In the Drawings

REMARKS

This is a full and timely response to the outstanding Action mailed September 20, 2005.

FIG. 7

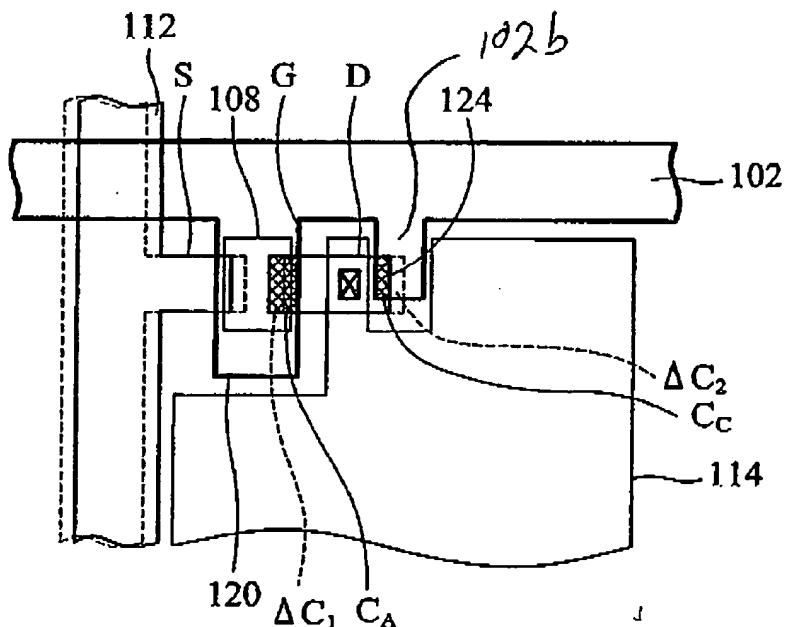
Please amend Fig. 7 (adding a label "102b") as show in the accompanying drawing sheets.
